Addendum 1 for RFB927940-04

Project Name: WRC Decentralization Phase 4 & Fire Alarm Phase 3 (9279.40 & 9279.41) Bid Issuance #4
DAS RFB #: 927940-04
DAS Project #: 9279.40 & 9279.41
Date: 5/21/2026

CHANGES TO DRAWINGS

13-MD202

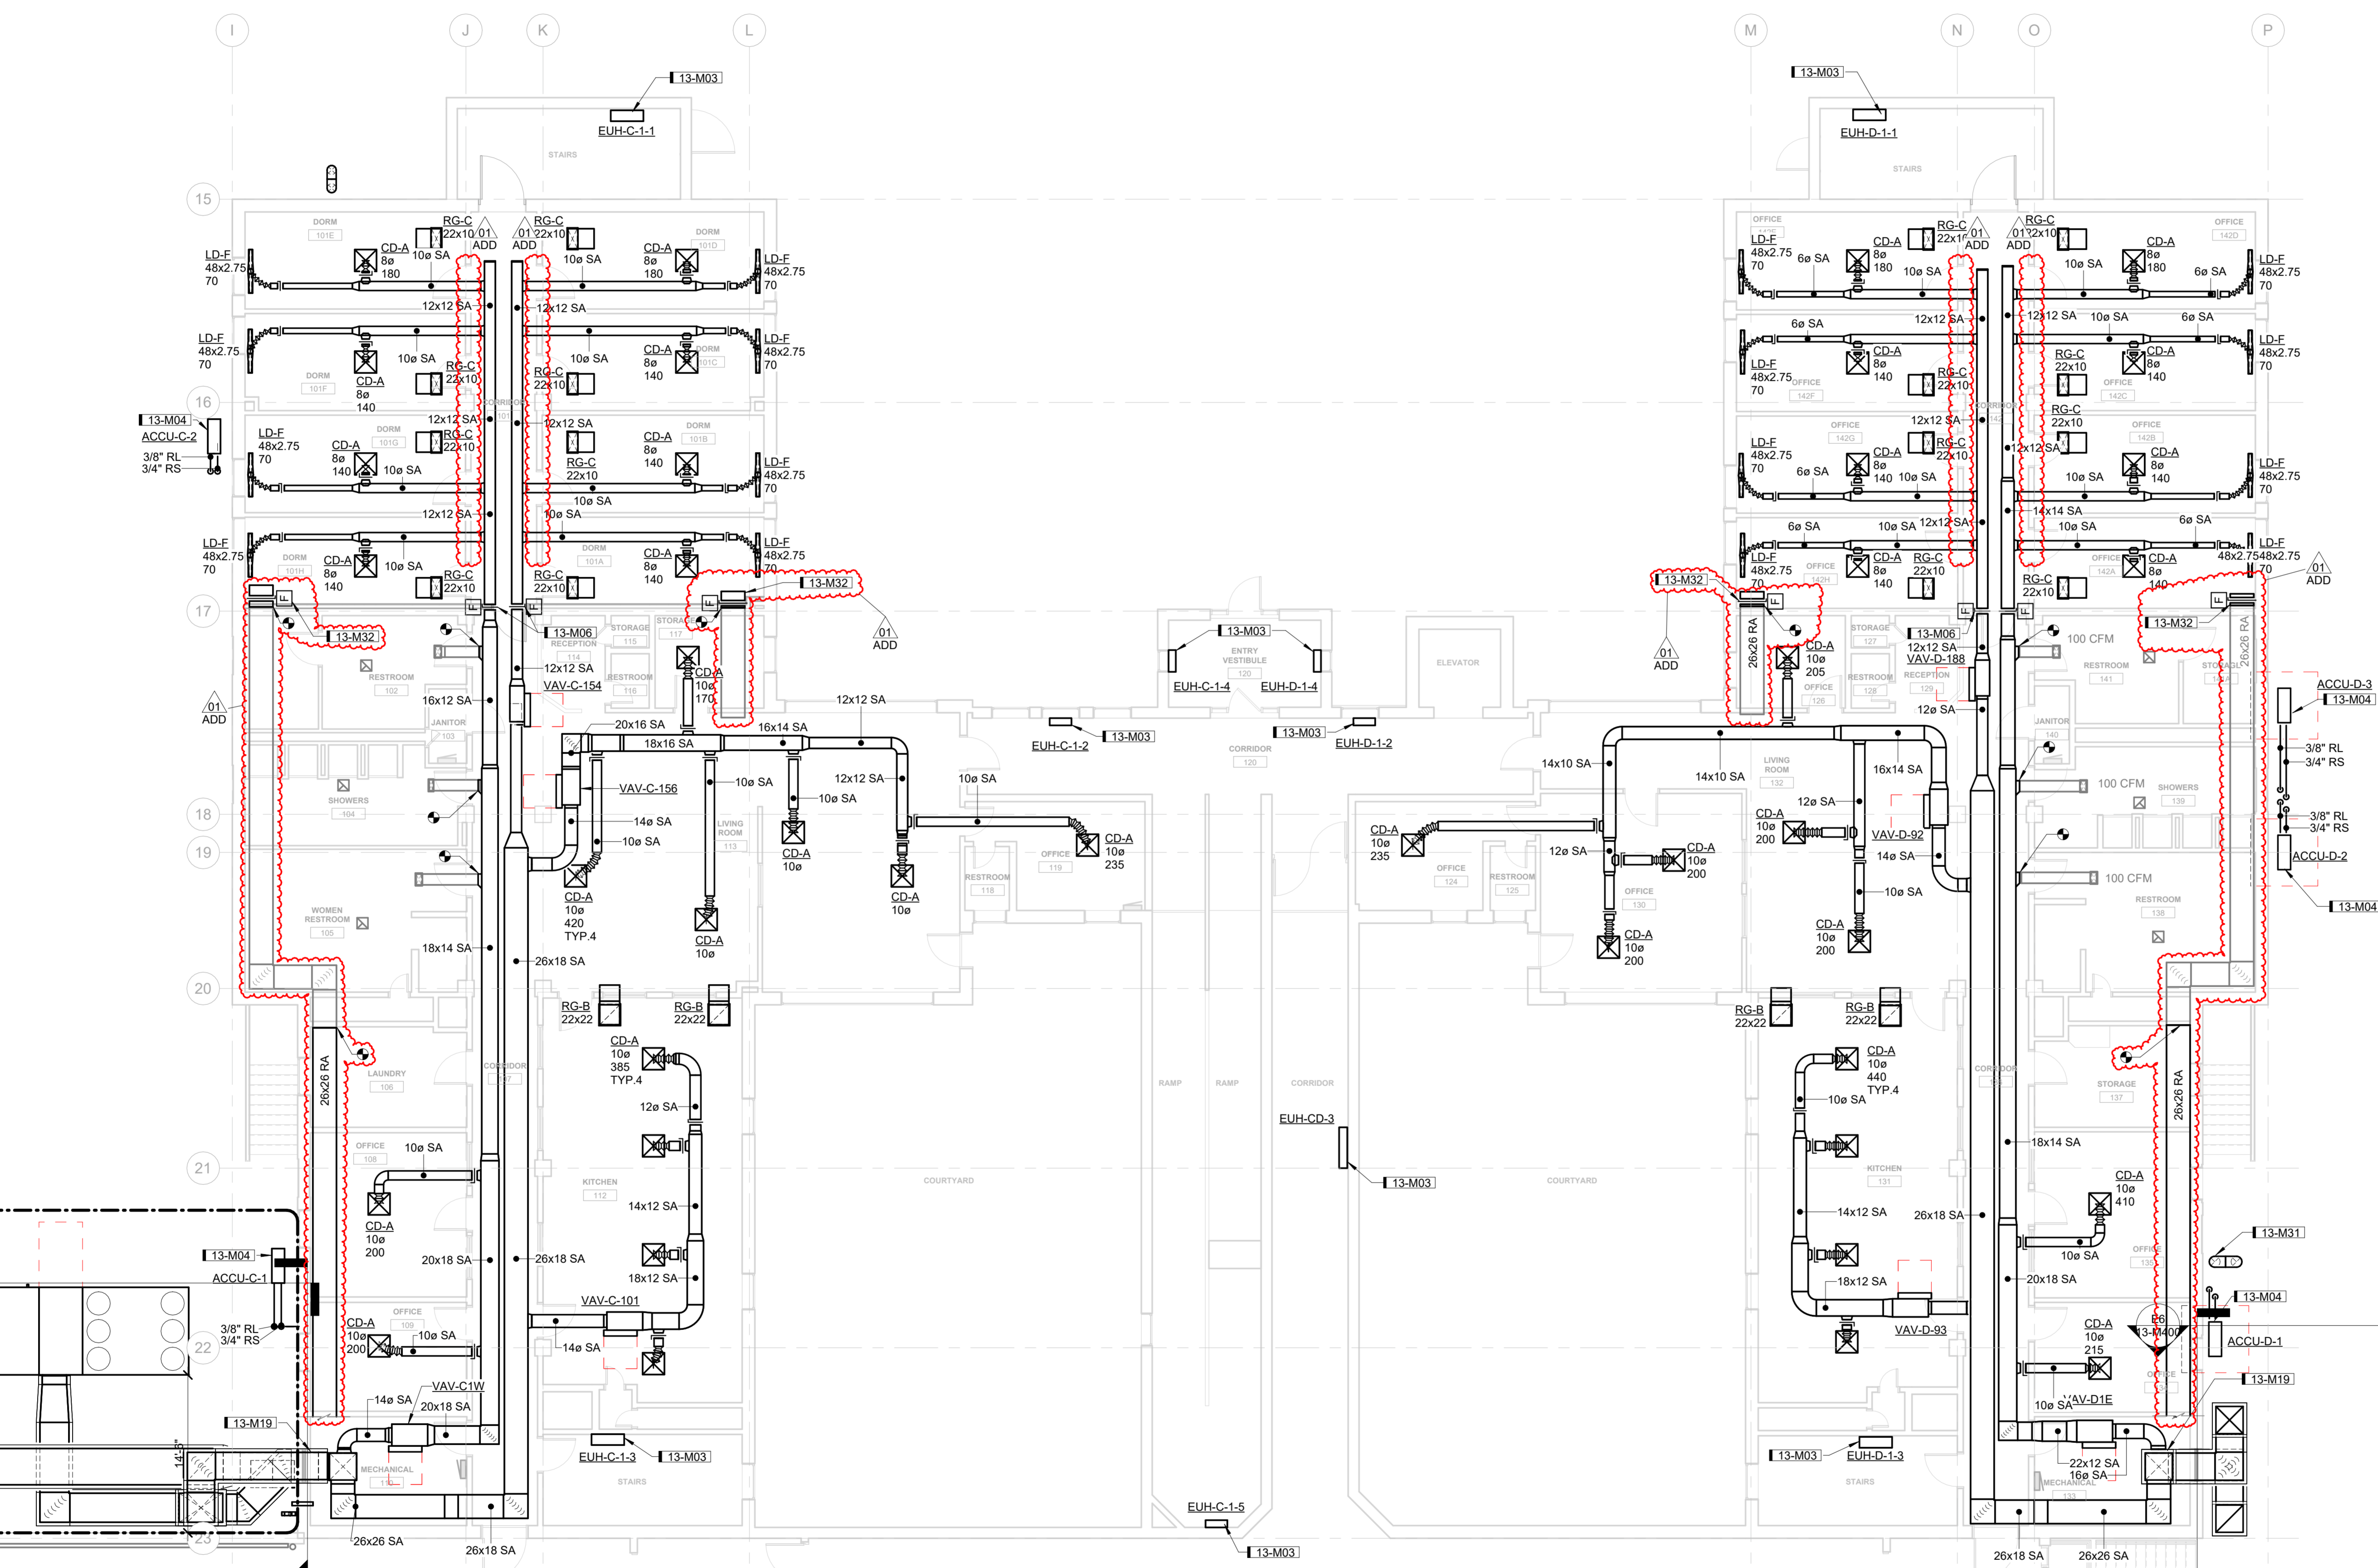
- **ADD** existing return transfer ducts and associated demolition.
 - **REVISE** keynote 13-MD16
 - **ADD** keynote 13-MD20
- **13-MD202 – SECOND FLOOR MECHANICAL DUCTWORK DEMOLITION PLAN:**

- **ADD** existing return transfer ducts and associated demolition.
 - **REVISE** Keynote 13-MD16
 - **ADD** Keynote 13-MD20
- **13-M200– BASEMENT MECHANICAL PLAN:**

FIRST FLOOR MECHANICAL DUCTWORK PLAN
13-M201

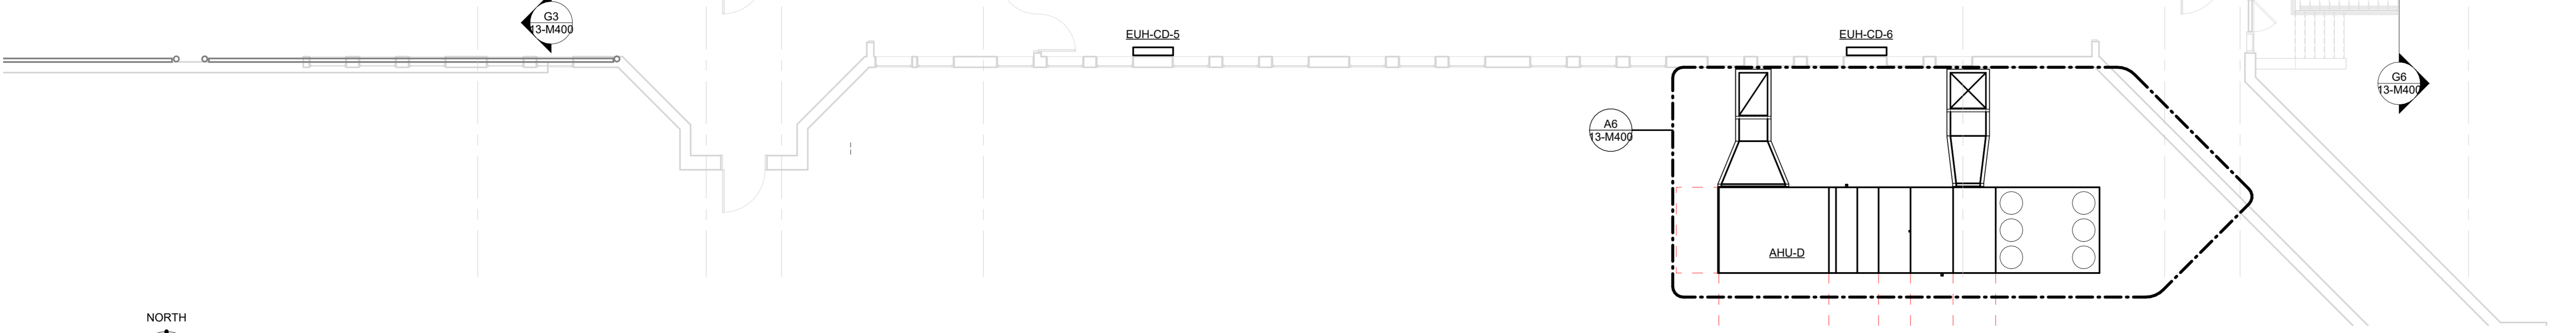
- **REVISE** ERV Ductwork Area D.
- **13-M201 – FIRST FLOOR MECHANICAL PLAN:**
 - **REMOVE** fire dampers between corridor and individual dorm walls.
 - **ADD** return ductwork and fire dampers.

- **ADD** Keynote13-M32
- **13-M202 – SECOND FLOOR MECHANICAL PLAN:**
 - **REMOVE** fire dampers between corridor and individual dorm walls.
 - **ADD** return ductwork and fire dampers.

13-M202

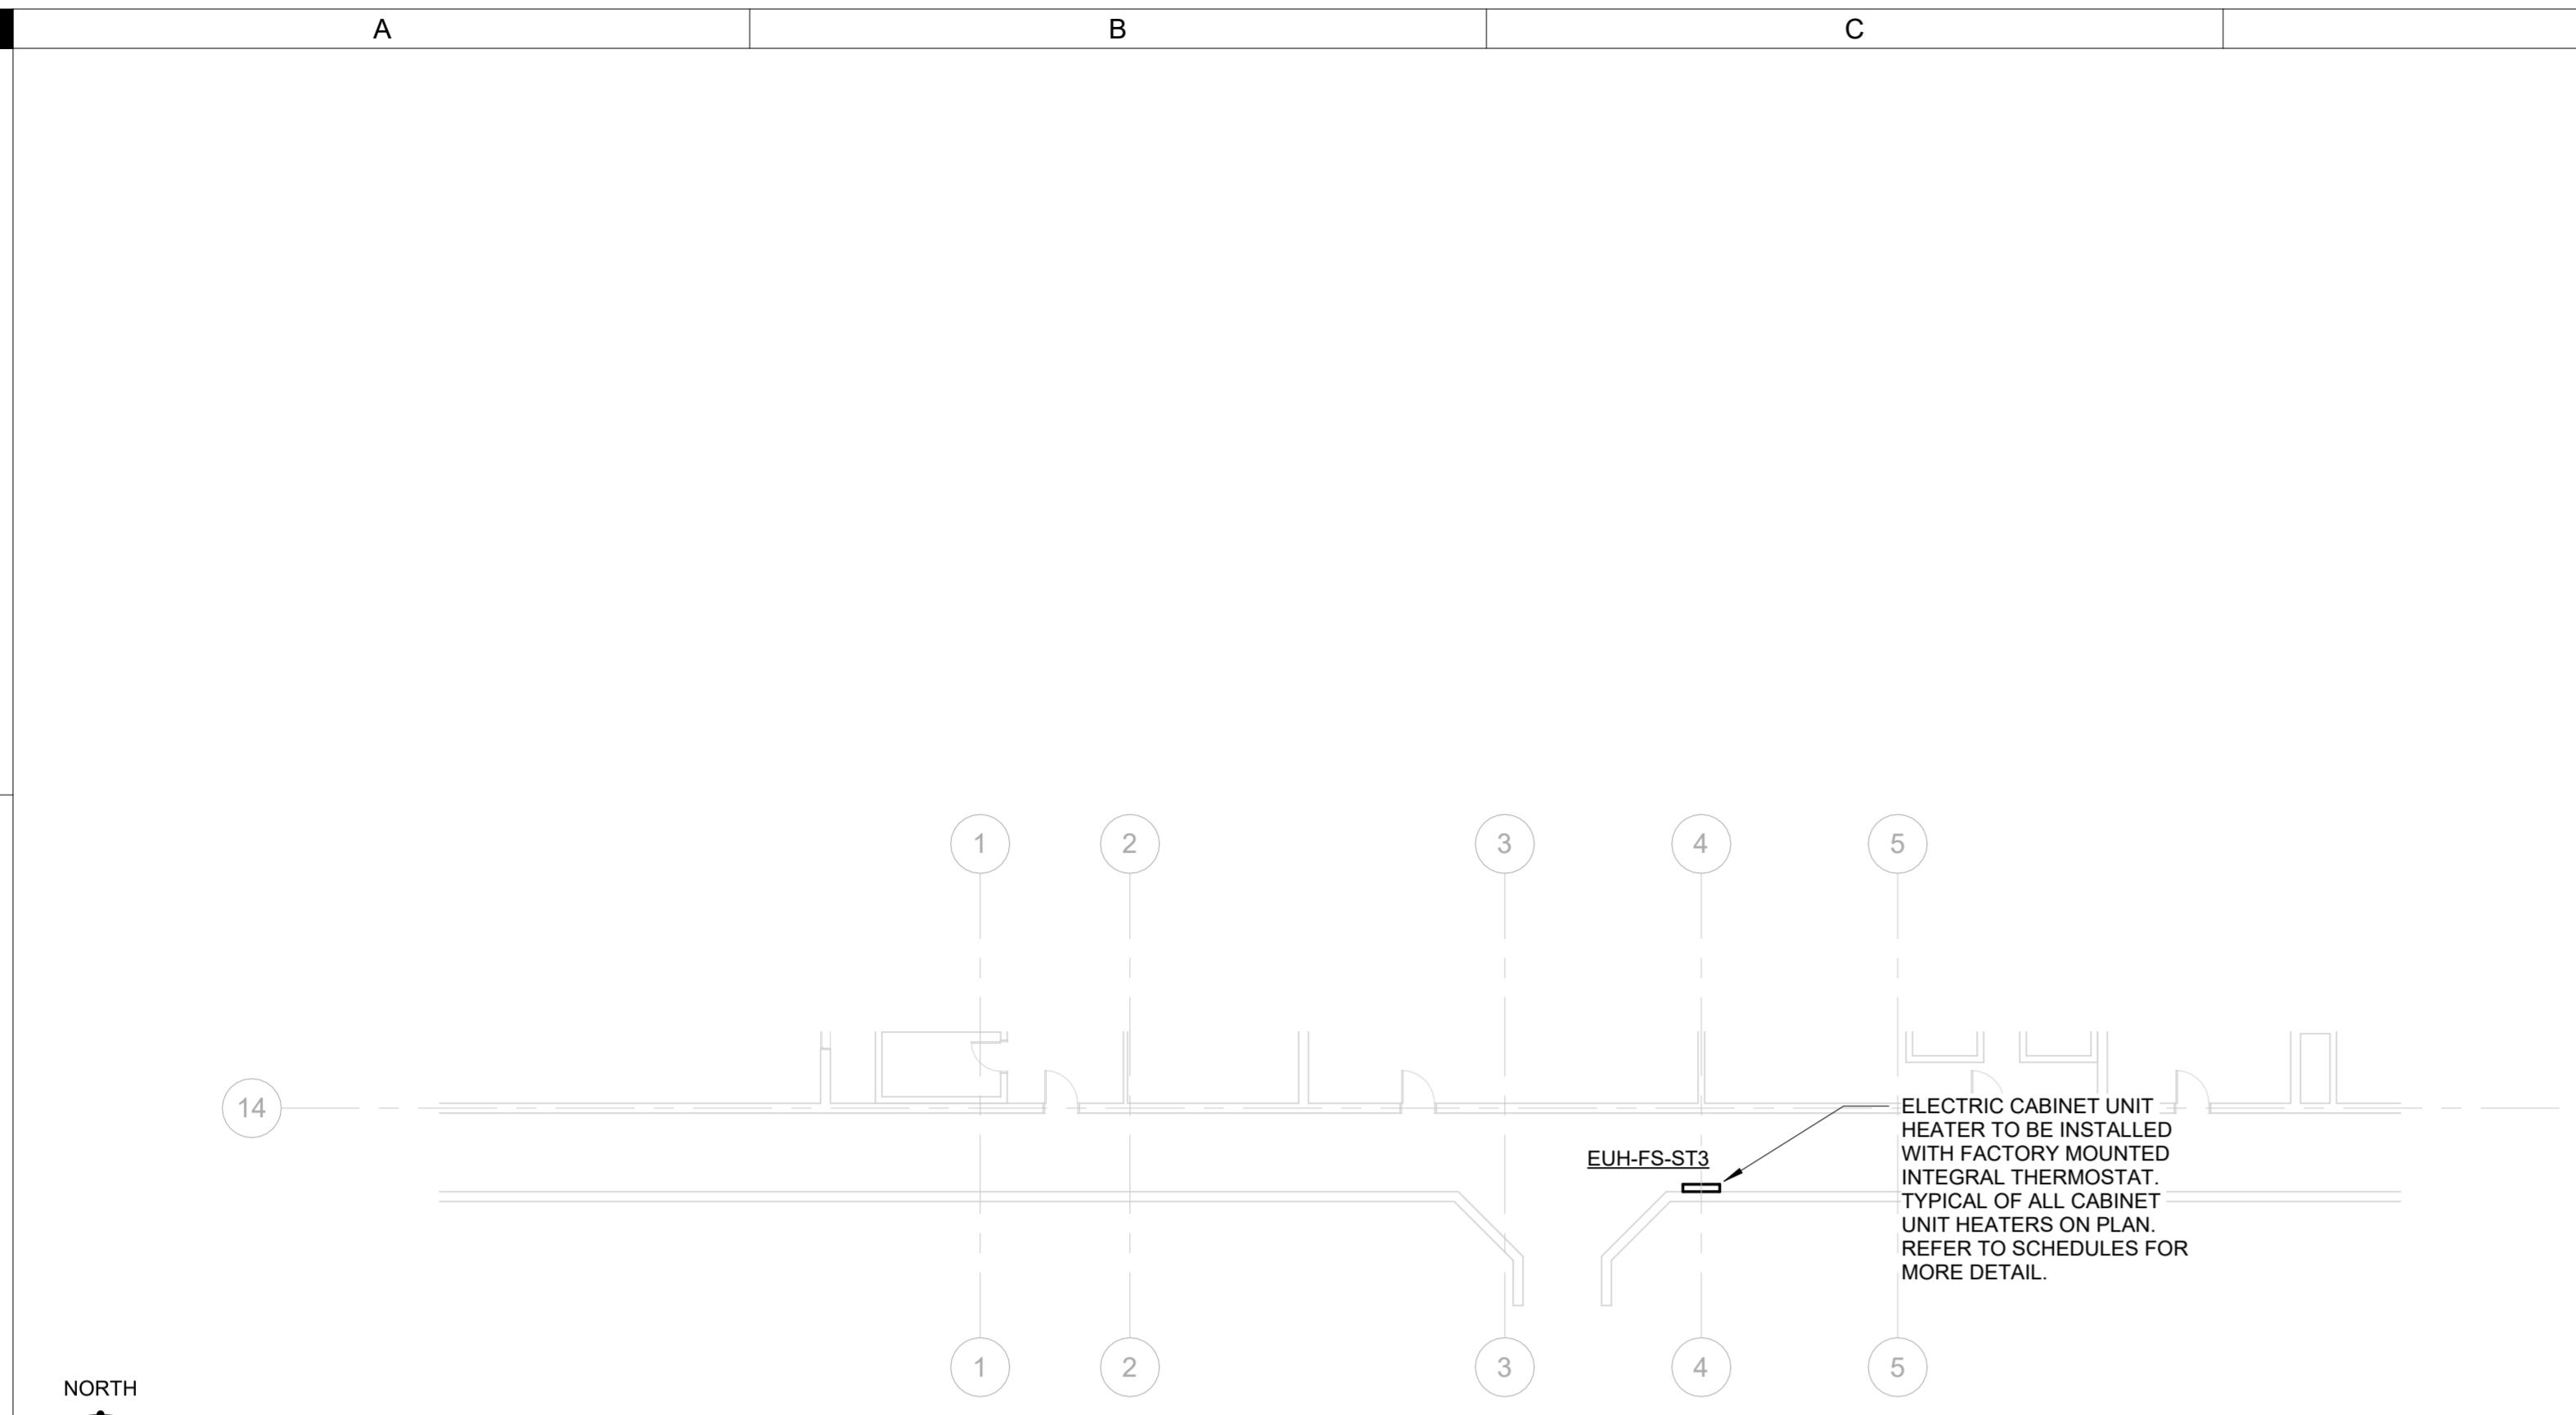
- **ADD** Keynote 13-M32
- **13-M300 – THERMOSTAT PLAN:**
 - **REVISE** thermostats in Area D Basement.
- **13-M501 –MECHANICAL CONTROLS:**
 - **ADD** ERV control sequence.
